A REPAIR

SEWAGE DISPOSAL SYSTEM

Charles Custer IS PERMITTED TO INSTALL _____ ALTER X

PLOT PLAN FOR ADDITION:
 CHARLES & LINDA CUSTER
 8579 OLD FREDERICK RD.
 ELLICOTT CITY, MD. 21043

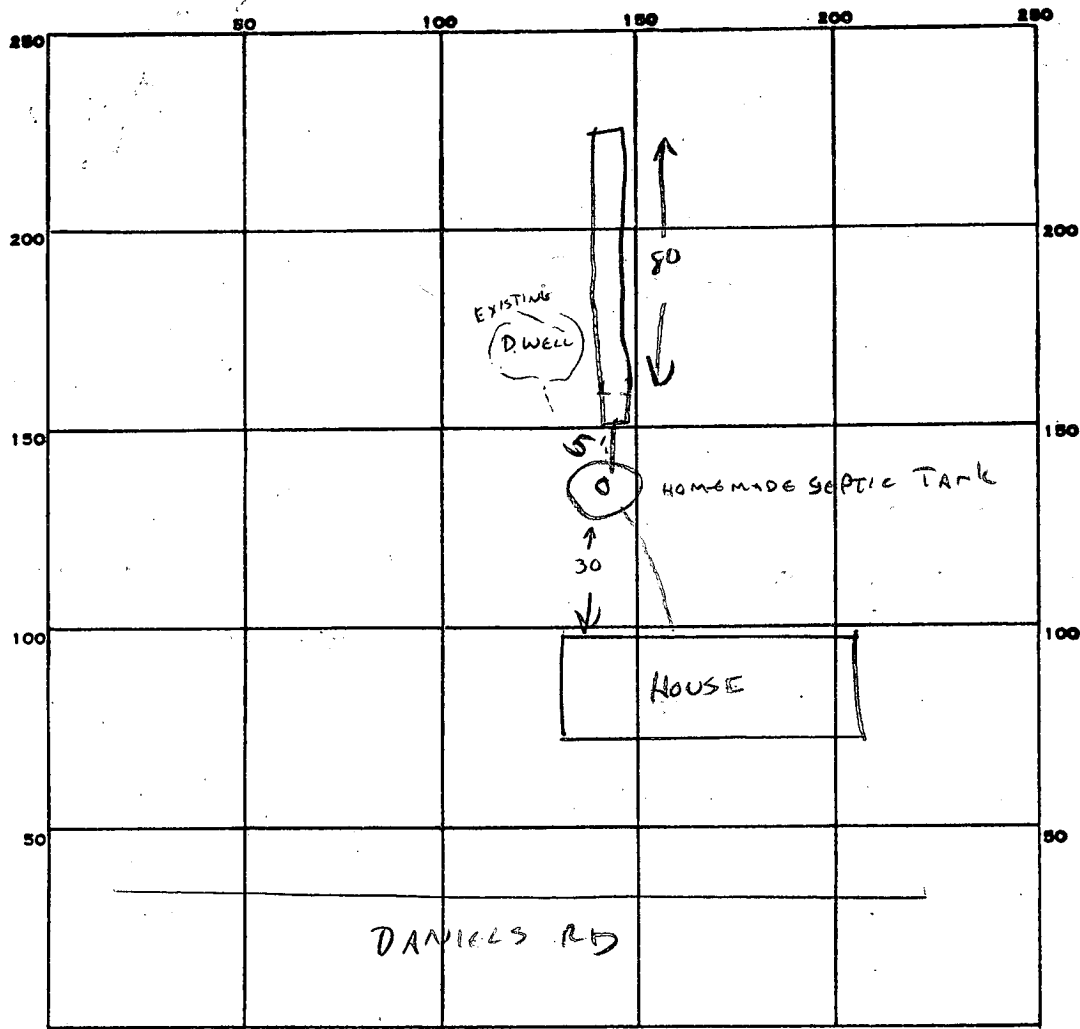
Talked with Mrs. Custer. Septic tank is partially uncovered, some made with concrete. DRAWN BY JOE MOINEAU
 top. No visible sewage problems. JUNE 1984-
 plenty of repair area. I told Mrs. Custer we would probably need to see one hole dug for repair area. J

PERMIT CARD

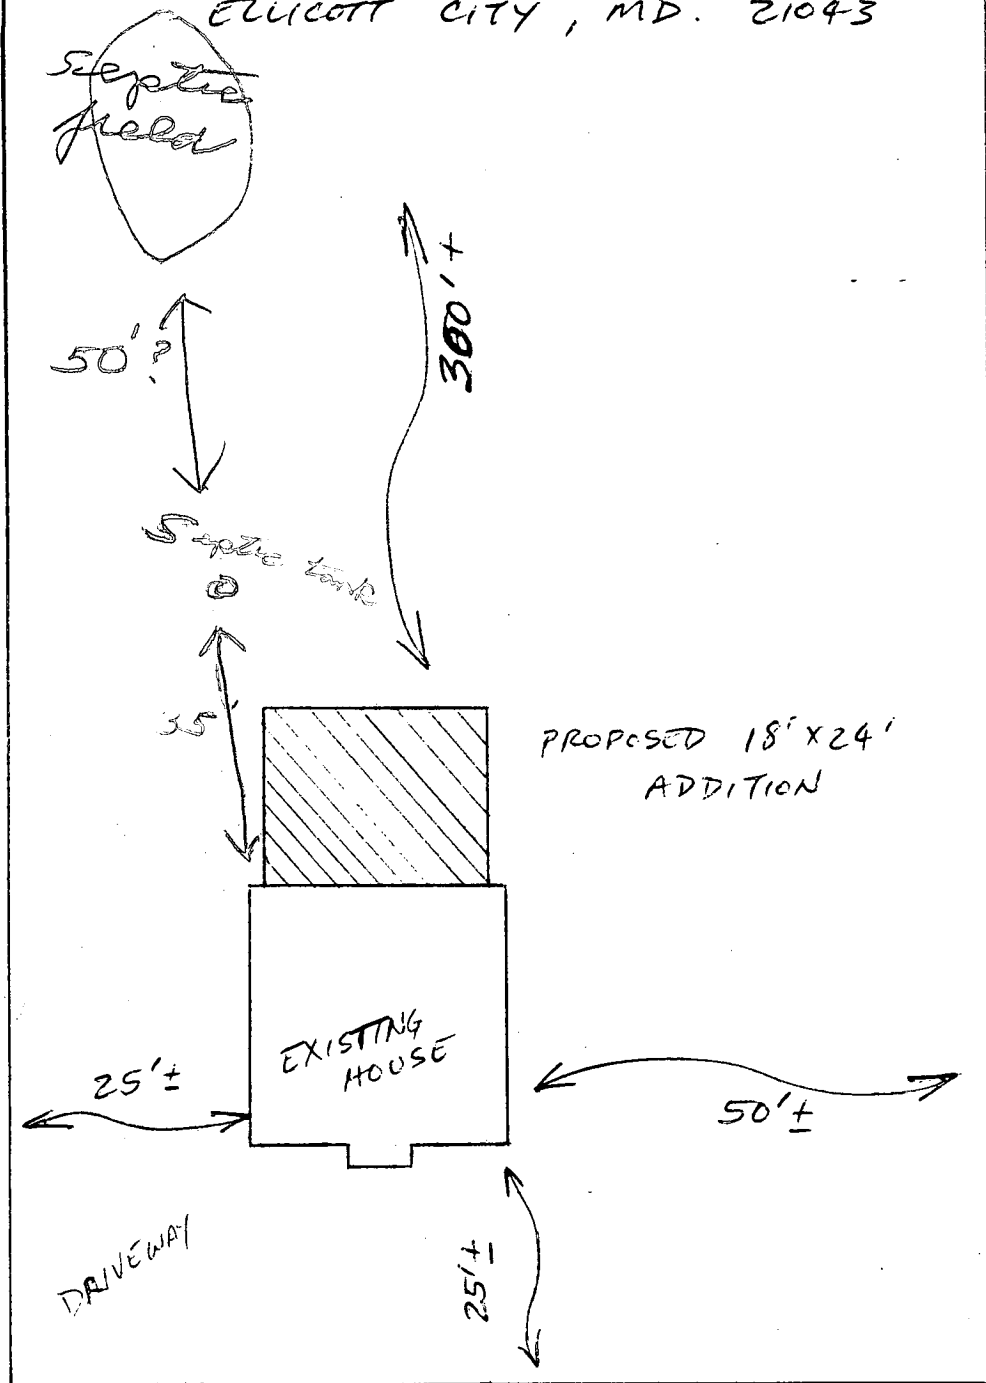
OK TO ADD GRAVEL TO TRENCH. MUST RUN NEW PIPING + ADD CLEANOUT 6/27/84 CW
6/28/84 OK to cover all work. J
